BARNUM ADDITION

WICHITA, SEDGWICK COUNTY, KANSAS

RE: S/D 97-73 - One-Step Final Plat of BARNUM ADDITION

At the regular meeting of the Subdivision Committee of the Metropolitan Area Planning Commission on Thursday, October 9, 1997, the above captioned plat was considered. The action of the Committee was to recommend that this plat be approved subject to:

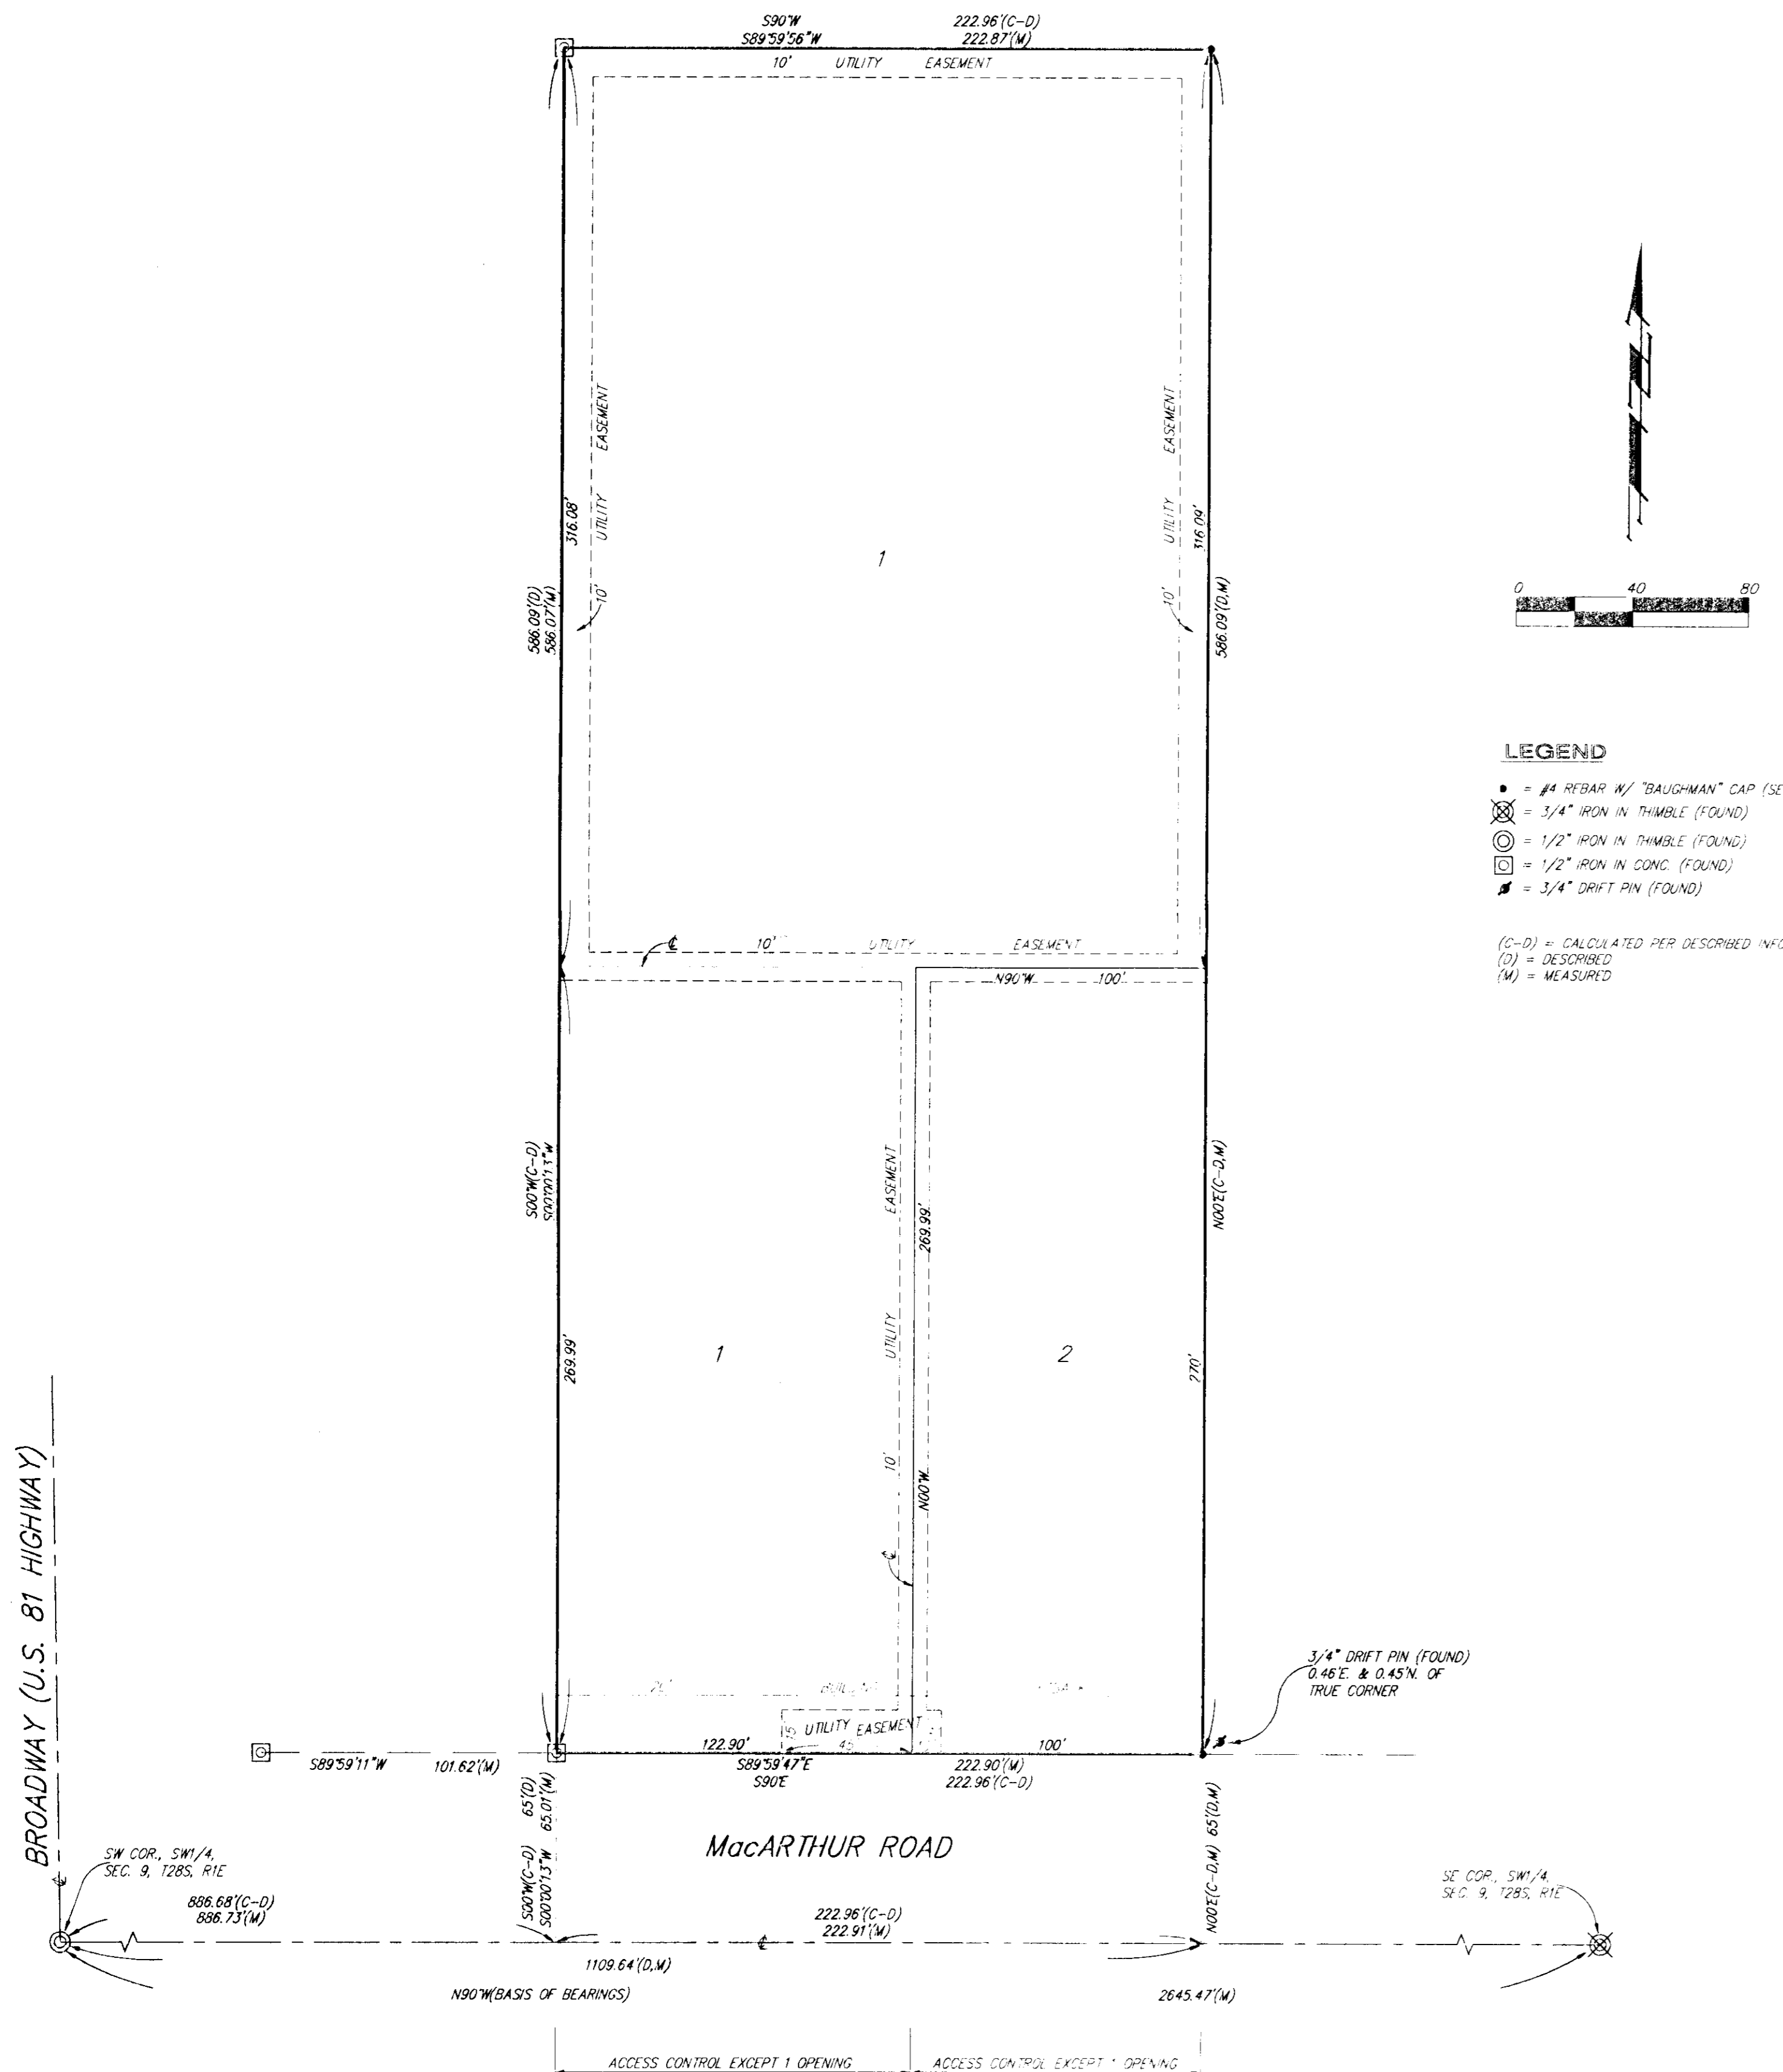
- A. It appears existing sewer and water service are available to the site. Engineer will need to comment on any guarantees or easements needed. *The applicant shall guarantee the extension of sanitary sewer to serve the lots being platted.*

- B. Engineering needs to comment on the status of the applicant's drainage plan. *Engineering comments that the plan is acceptable. Applicant will need to provide an off-site drainage agreement.*

- C. Traffic Engineer needs to comment on the acceptability of access controls, and if any improvements are needed to MacArthur Road. *Traffic Engineering has required one point of access to each lot.*

- L. The MAPC Chairman signature block should be revised to read Richard Lopez.
- M. The applicant's agent is advised that the land being platted does not correspond with the legal description on the platter's text and in the platting binder.

- N. The applicant shall guarantee the closure of any driveway openings that exceed the number of allowed openings.
- O. This property is within a zone identified by the City Engineers' office as likely to have groundwater at some or all times within 10 feet of the ground surface elevation. Building with specially engineered foundations or with the lowest floor opening above groundwater is recommended, and owners seeking building permits on this property will be similarly advised. More detailed information on recorded groundwater elevations in the vicinity of this property is available in the City Engineers' office.
